Charlotte Department of Transportation

Memorandum

Subject: Rezoning Petition 15-095: Approximately 24.7 acres located on the west side of East Craighead Road between North Tryon Street and North Davidson Street.

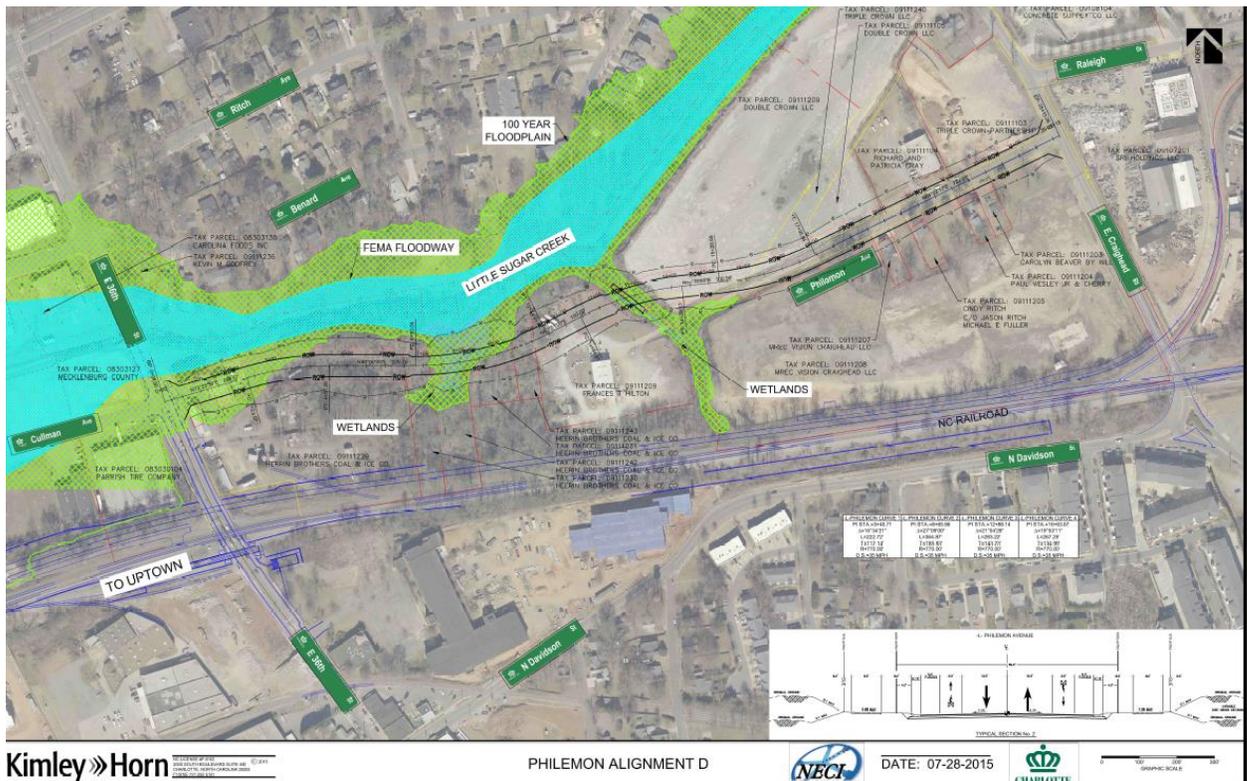
- The total street width needed to implement the proposed Philemon Ave. typical section is 87 feet. The petitioner needs to dedicate any additional right-of-way in fee simple and provide necessary sidewalk utility easements (SUE) that will total 87 feet to the City of Charlotte. See Philemon Ave.'s conceptual alignment, typical section, right-of-way and SUE needs below.
